ALPINE CITY PLANNING COMMISSION MEETING

NOTICE is hereby given that the **PLANNING COMMISSION** of Alpine City, Utah will hold a **Public Hearing and a Regular Meeting at Alpine City Hall**, 20 North Main, Alpine, Utah on **Tuesday, February 3, 2015 at 7:00 pm** as follows:

SUBJECT: State Farm Insurance Building Site Plan

**Subject: Planning and Zoning Review
State Farm Insurance Building Site Plan
134 South Main Street**

State Farm Insurance Building Site Plan

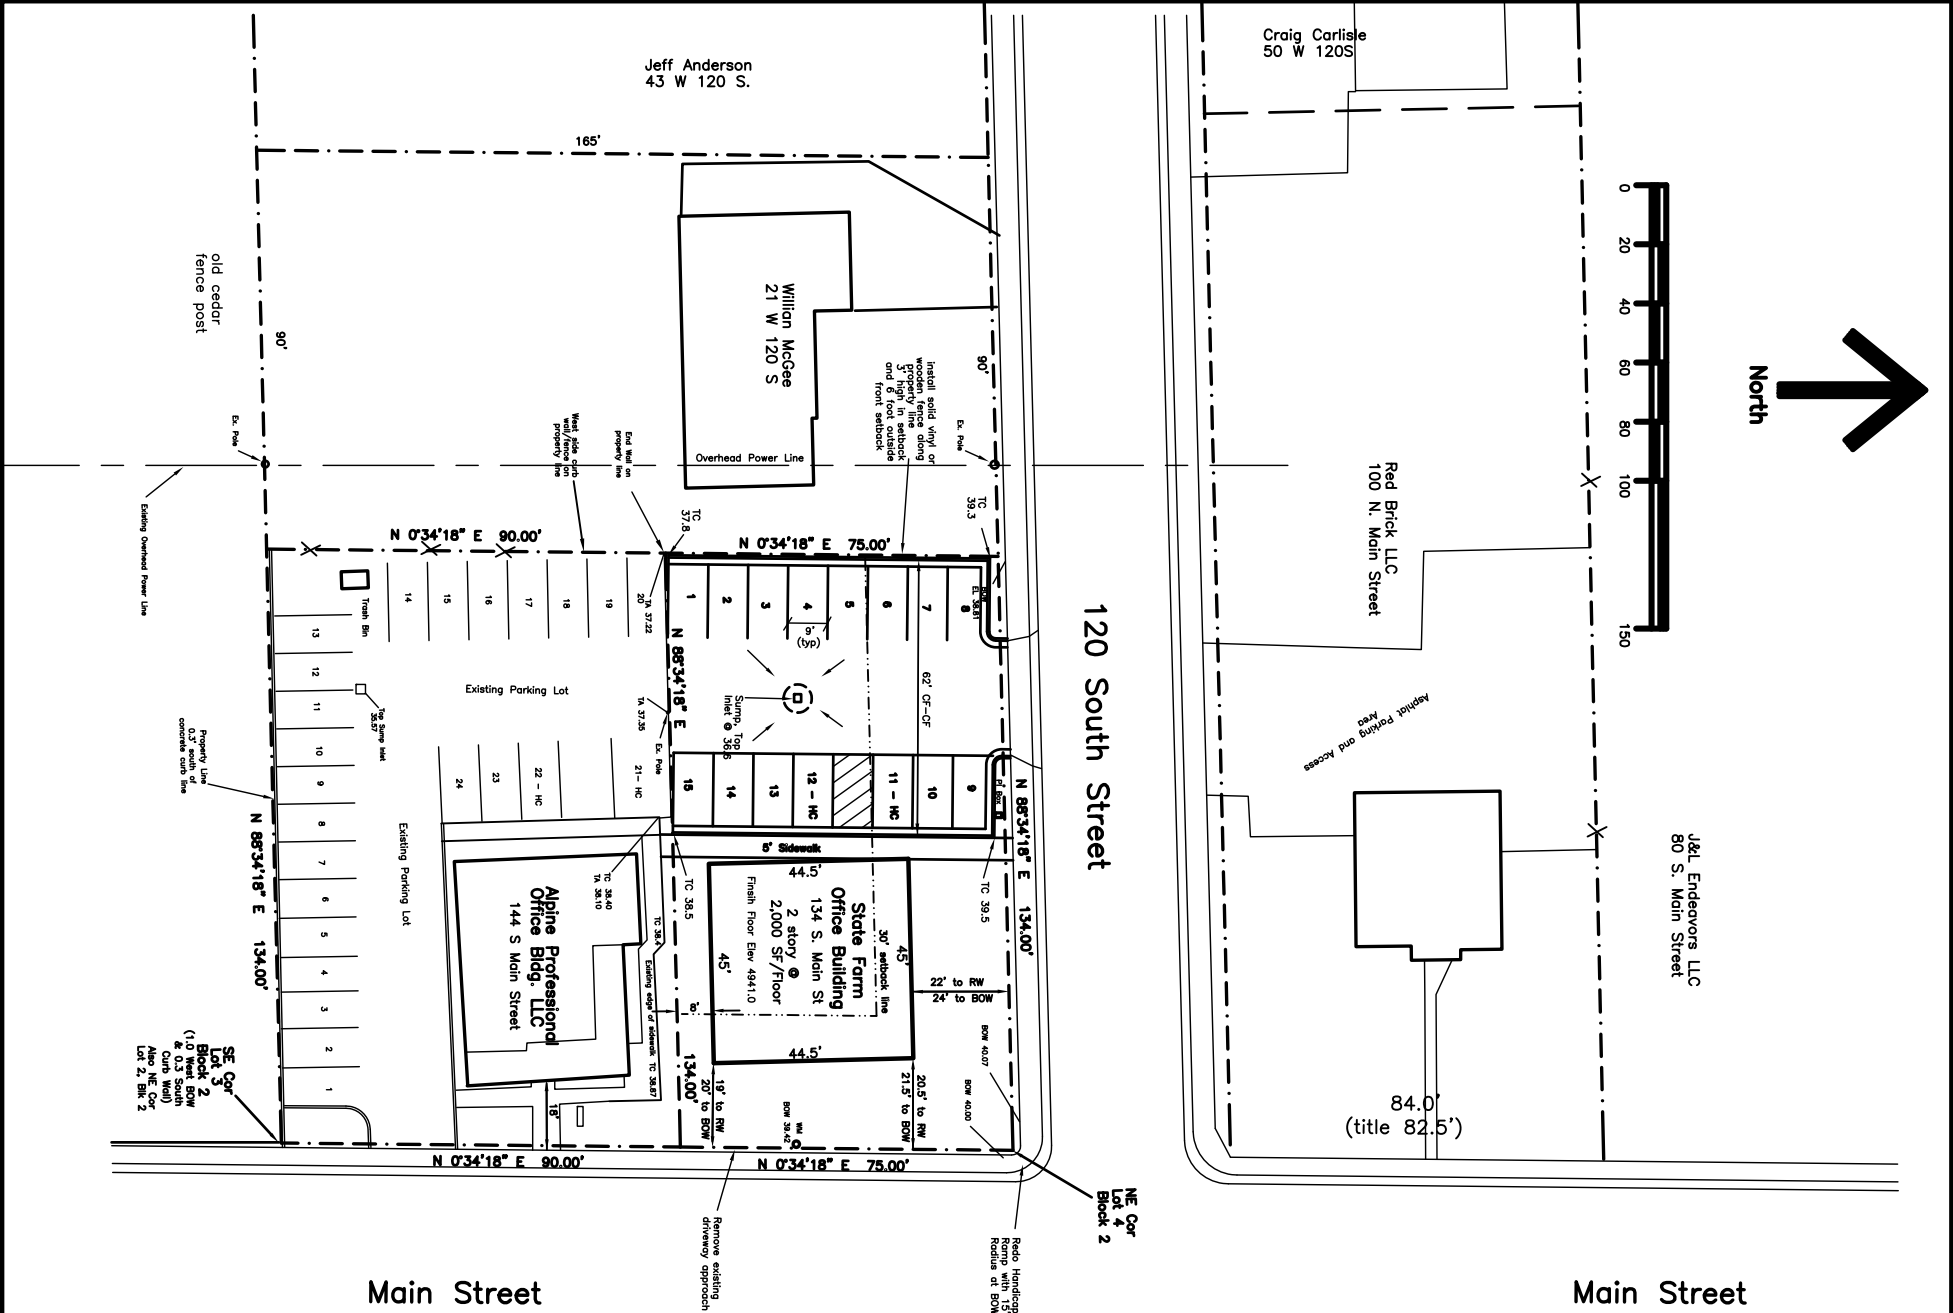
The proposed office building will need an exception from the setback requirements. This requires a recommendation from the Planning Commission and an approval from the City Council where circumstances justify. The applicant is proposing to have a 22' setback (8' exception) from 120 South, a 20' setback (10' exception) from Main Street, and an 8' setback (12' exception) from the property line to the south. From a planning perspective, I offer my support on these exceptions.

The site plan shows 15 parking stalls. With the square footage of the building, 16 parking stalls are required. The applicant proposes to use an excess stall on the adjacent property to the south and connect parking lots for traffic circulation. An agreement would be made between the property owners. Based on calculations of the adjacent building received from the applicant's engineer, it appears that there are 4 more parking stalls than are required. From a planning perspective, I offer my support on this proposed agreement.

The site plan proposes to access the site from 120 South. A new drive approach will be created there removing curb, gutter, and sidewalk. The existing drive approach on Main Street will be replaced with standard curb, gutter and sidewalk. To mitigate the negative impact of street parking, it is proposed that the curb fronting 120 South and Main street be painted red to prohibit parking.

The parking stall and aisle dimensions meet the minimum requirements. However, there are 6 stalls that are located within the required 30' setback (Section 3.7.5.1). The Planning Commission will need to recommend an exception to the City Council for approval in order for these 6 stalls to remain on the plan as is. From a planning perspective, I offer my support on this exception.

The parking stall dimensions, surface material (asphalt), concrete work, and new ADA ramp at the corner of 120 South and Main appear to meet code. It is not specified on the plan, but it would be required that the new driveway ramp be 6-inch thick concrete, the standard design for a typical commercial driveway approach.

The site plan does not mention any specific lighting plan for the parking; this will need to be discussed prior to approval.

The site plan proposes a sump system to retain all onsite drainage however no calculations or details were provided with this proposal. As a condition of approval, details and calculations would be required.

There are some minor redlines on the plan to be corrected

- **An exception be considered by the Planning Commission and City Council regarding setbacks.**
- **An exception be considered by the Planning Commission and City Council regarding six (6) parking stalls location within the setback.**
- **An agreement provided between property owners regarding the excess parking stall proposed to be on the adjacent property be considered by the Planning Commission and City Council.**
- **No trees be planted within the sight triangle and other landscaping be placed in a way that will never affect visibility on the Corner of 120 South and Main Street.**
- **The preliminary architectural design drawings be considered by the Planning Commission and City Council.**

- **The Developer provide storm drainage calculations and details for the plan**
- **The Developer address the site plan redlines**
- **The Developer provide a lighting plan**
- **The Fire Marshal approves the site plan**

REDI-ROCK WALL DESIGN WITHOUT GEOGRID

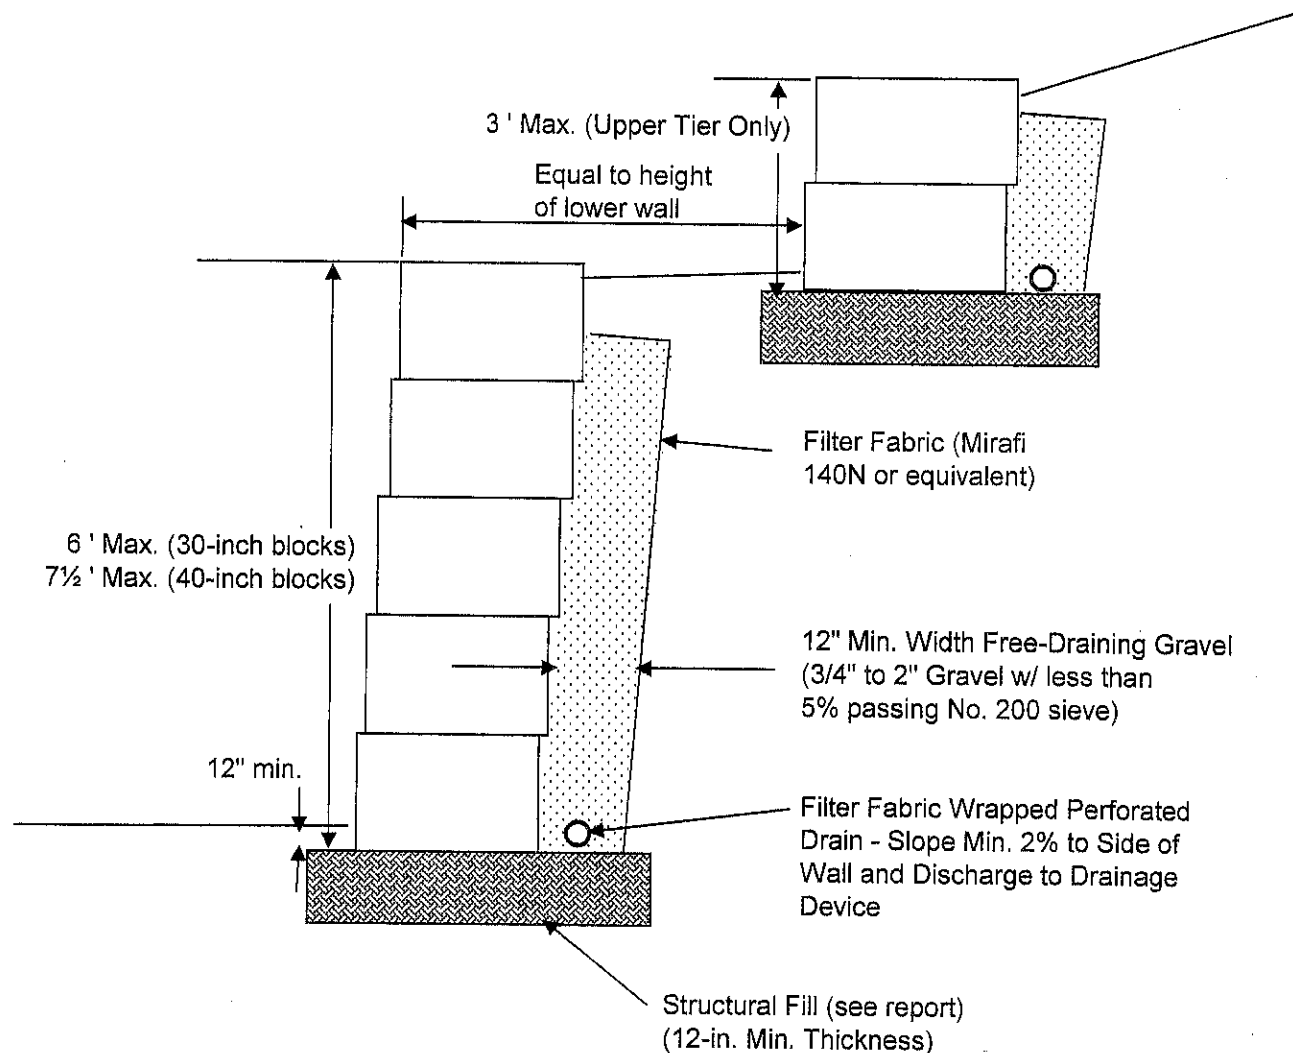
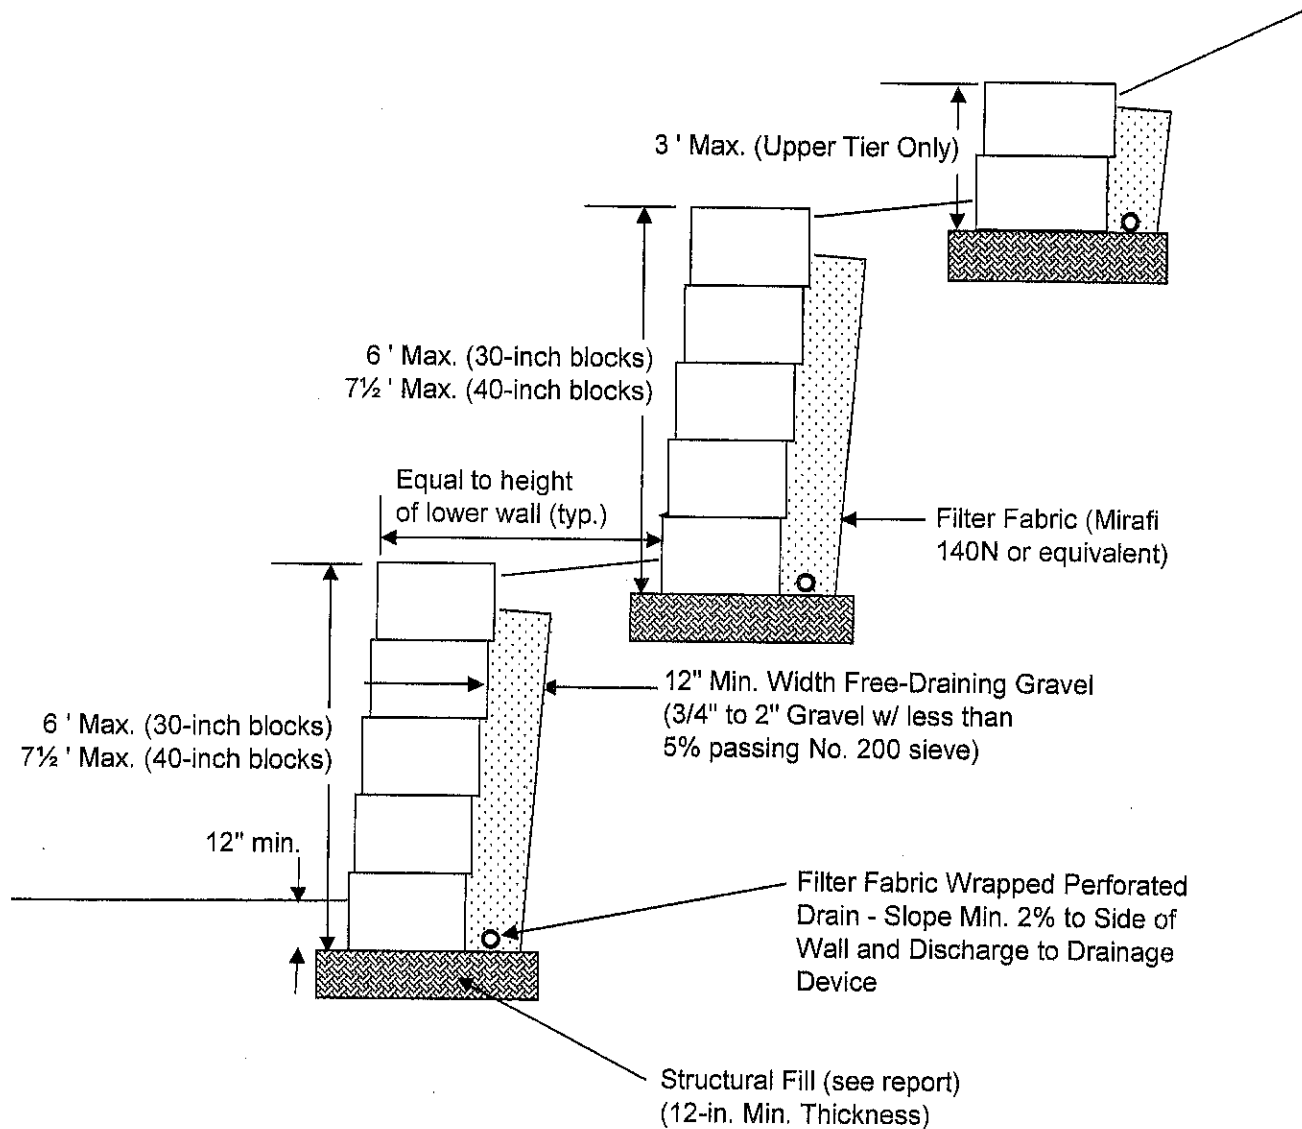
applied the clayey gravel parameters instead of the lean clay parameters to the Redi-Rock wall evaluation shown in Figure 1 of the reviewed report.

Attached is a revised Figure 1 with the lean clay parameters for retained soils and structural fill (bottom row of blocks should be placed on a 1-foot thick structural fill pad) for the foundation interface. The analysis shown on the revised Figure 1 applies to the top row of Redi-Rock blocks, which would retain an approximate 2H:1V slope, and indicates that both 30-inch and 40-inch deep blocks would be stable up to 3 feet high in such situations. The lower blocks would retain level backfill but would also be subject to the surcharge imposed from the adjacent upper Redi-Rock wall tier. This analysis, shown on the attached Figure 1A, indicates that 30-inch blocks should not be used in these situations but that 40-inch blocks would be stable up to 7½ feet high for each tier, given a surcharge of 943 psf (145 pcf times 6½ feet of wall above the ground surface, which subtracts the 1 foot of embedment). Figure 11 has also been revised to reflect these changes.

LOCK+LOAD WALL WITH REINFORCEMENT

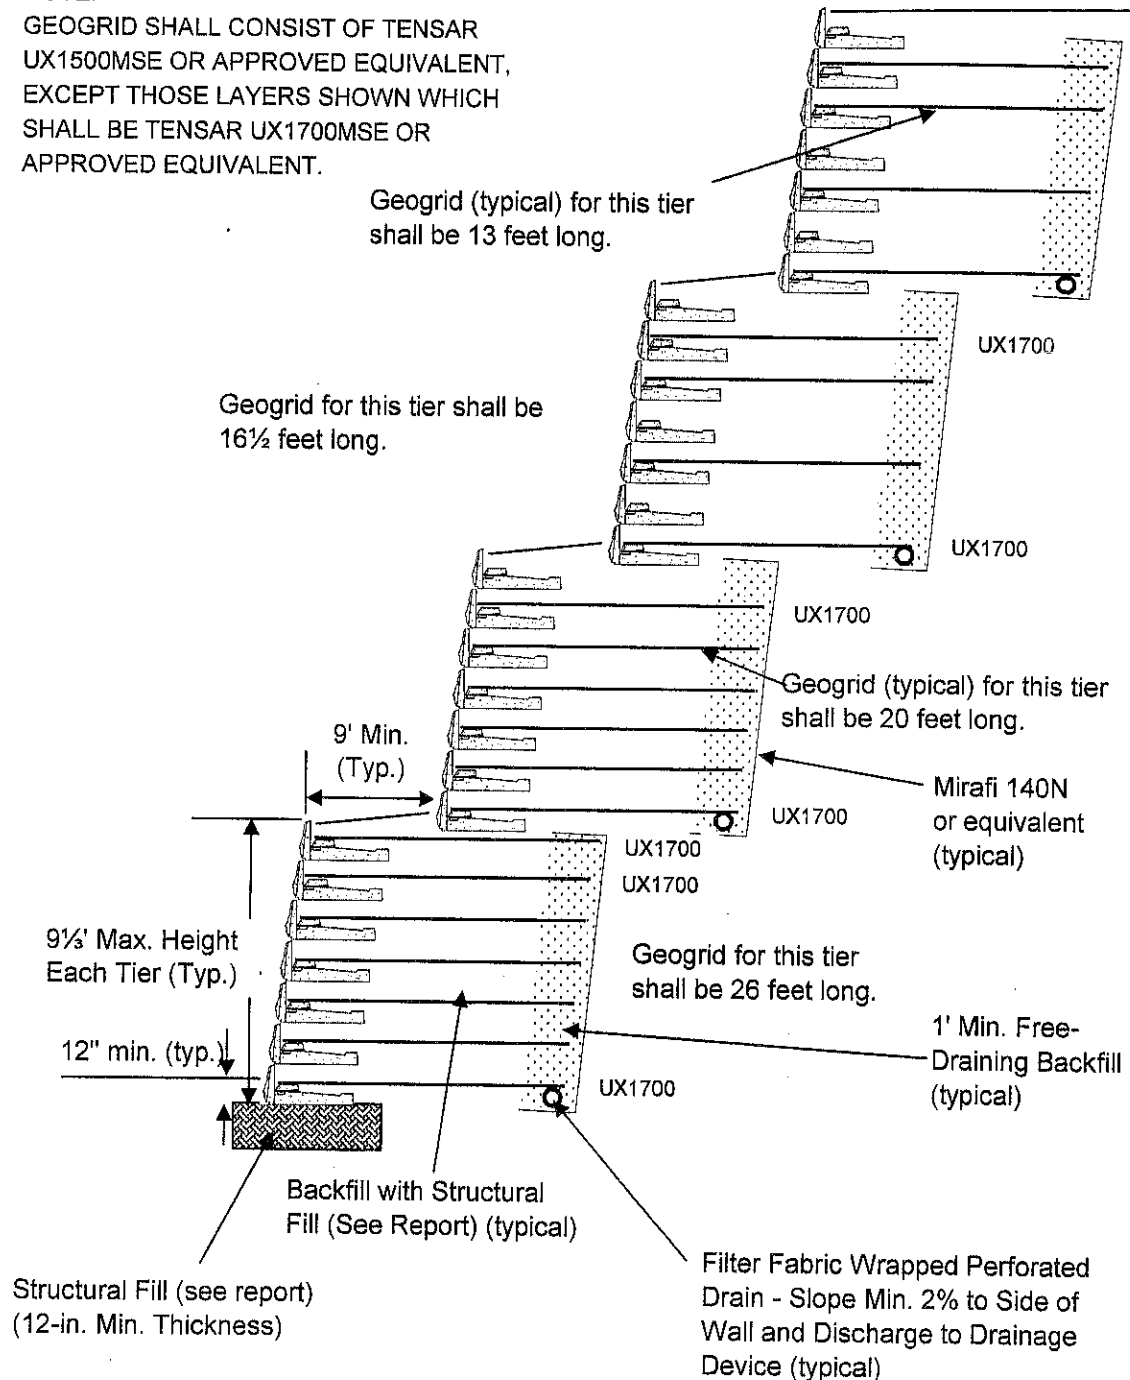
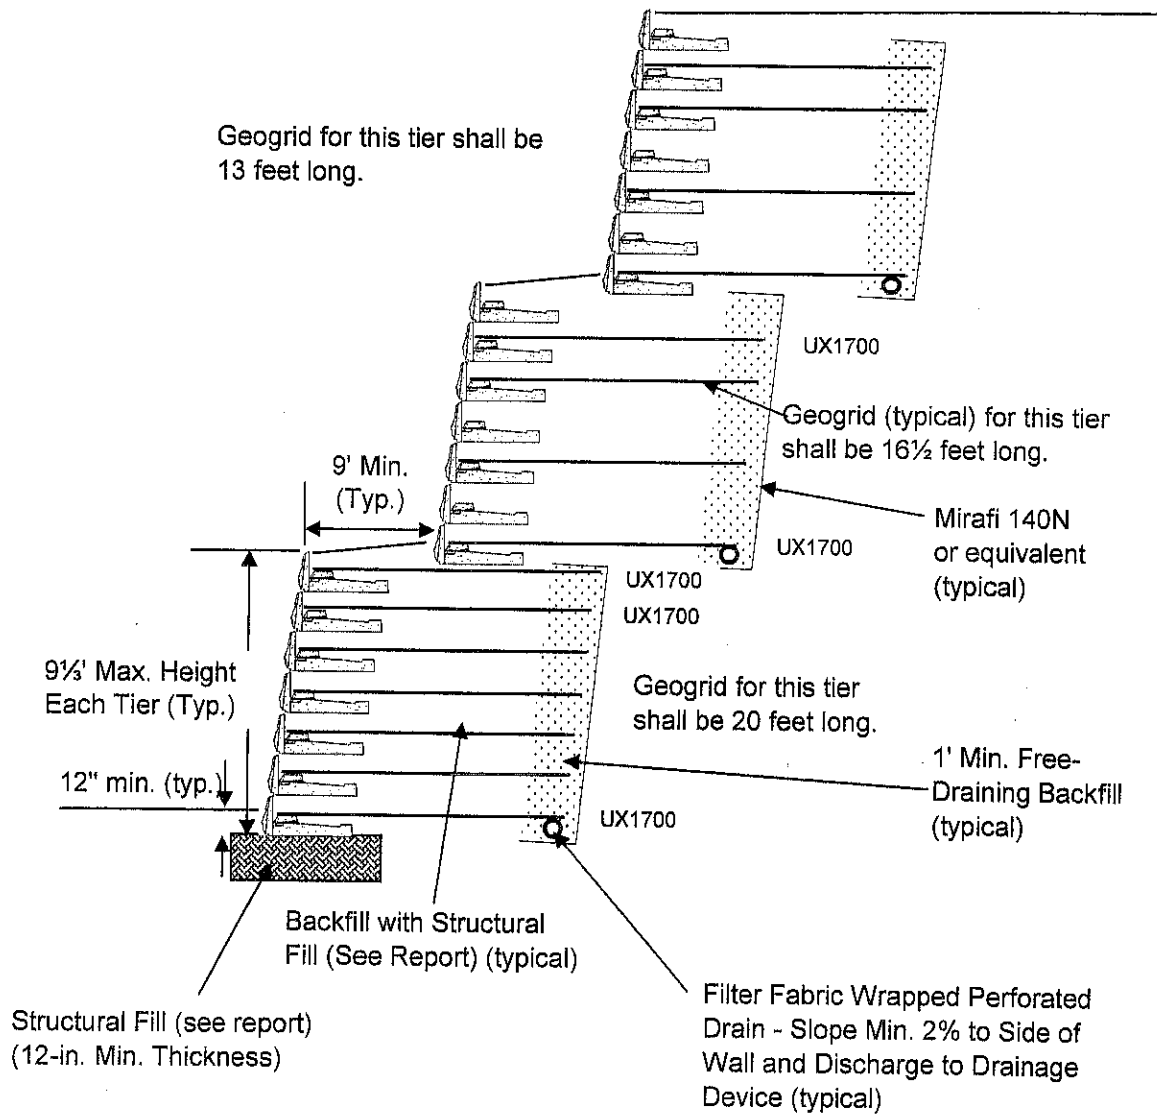
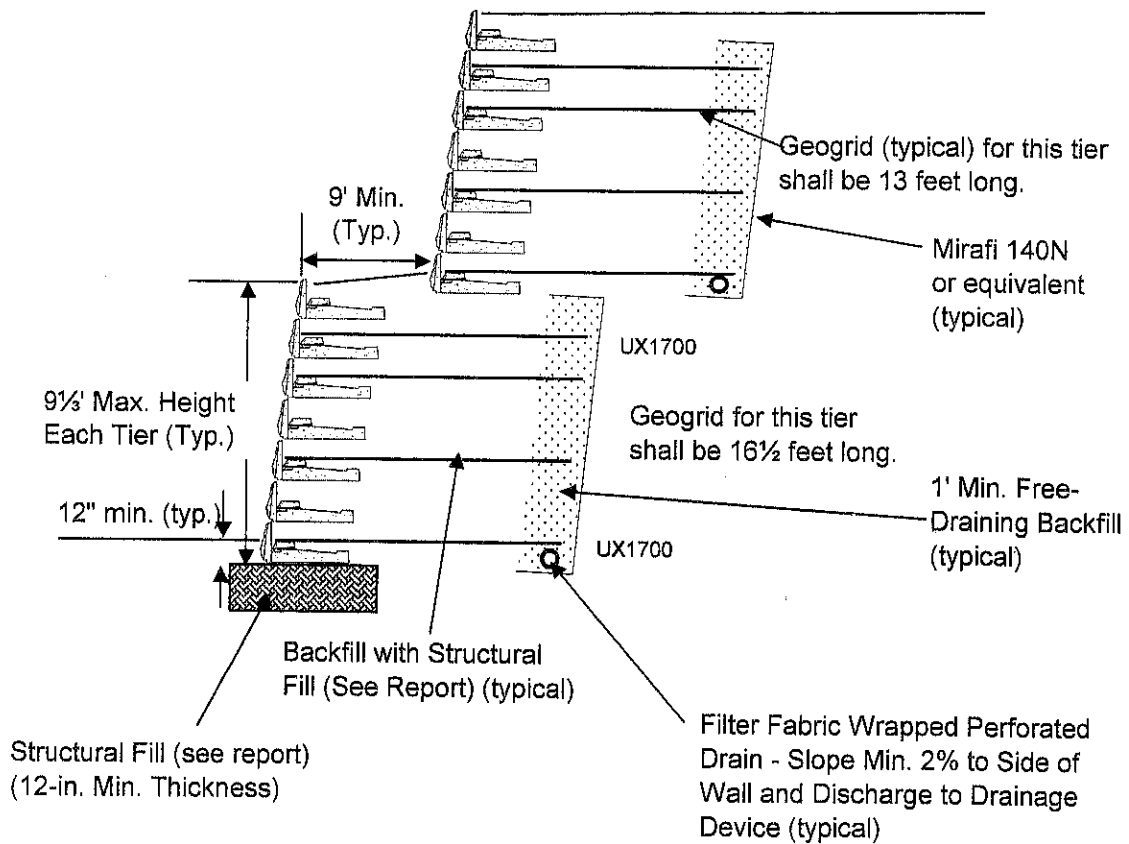
3. *TGE recommends to Alpine City that Earthtec or the developer provide a cross-section of each of the planned walls to aid Alpine City and the Contractor in the construction and inspection of the walls. This would include a correction to Figure No. 12 of the October 3, 2006 report and the correction of sheet VW10 of the subdivision plan sheets submitted by Sowby and Berg dated August 17, 2006.*

Figure 12 has been revised to show the geogrid layers at the mid-height of each Lock+Load block where such geogrid is needed. Additional figures (11A, 12A, 12B and 12C) also show cross-sections for each set of wall tiers.

Subsequent to our October 3, 2006 report, we submitted to the reviewer revised MSEW results (included in the Appendix, attached) wherein UX1700MSE geogrid was used in the bottom and top layers of soil reinforcement due to placing geogrid at mid-height of the Lock+Load blocks. The geogrid type that should be used for the bottom and top layers of reinforcement for all but the upper wall tier is UX1700MSE. This change is shown on the revised Figure 12 (and 12A, 12B, 12C as well), attached.
